ITS DISCUSSION OF DIFFERENCES

ITS Section 3.4B: Reactor Coolant System

Note: The ITS Section 3.4B package addresses the following NUREG-1430 RSTS:

Figure 3.4.16-1 (page 1 of 1)
Reactor Coolant DOSE EQUIVALENT I-131 Specific Activity Limit
Versus Percent of RATED THERMAL POWER With Reactor Coolant
Specific Activity >1.0 µCi/gm DOSE EQUIVALENT I-131

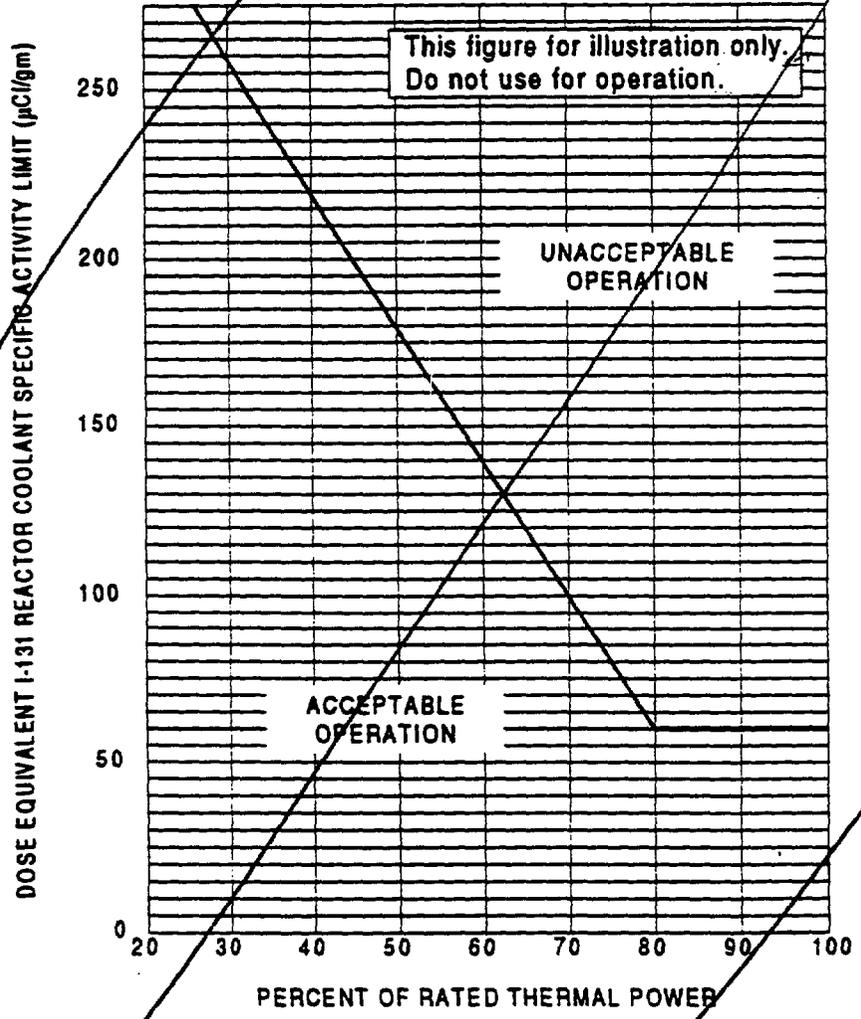
19 NUREG 3.4.16 and Bases - The CTS 3.1.4 requirements for RCS specific activity are retained. Editorially, the specific activity limits are listed in the LCO. The ACTIONS are revised to retain the single requirement to restore within 24 hours with no dependence on the Figure related to iodine spiking. These ACTIONS are consistent with CTS and with the CTS Bases which does not consider iodine spiking. The retention of the CTS requirements also combines NUREG Conditions B and C since these Required Actions are the same after including TSTF-028 which omits Required Action C.1. Also, the second entry condition of NUREG Condition B is unnecessary because: 1) it is the same as the first entry condition, i.e., if specific activity is too high Condition A is entered and Required Action A.1 is completed; and 2) the referenced figure does not exist due to the LCO modification. This change is consistent with current license basis.
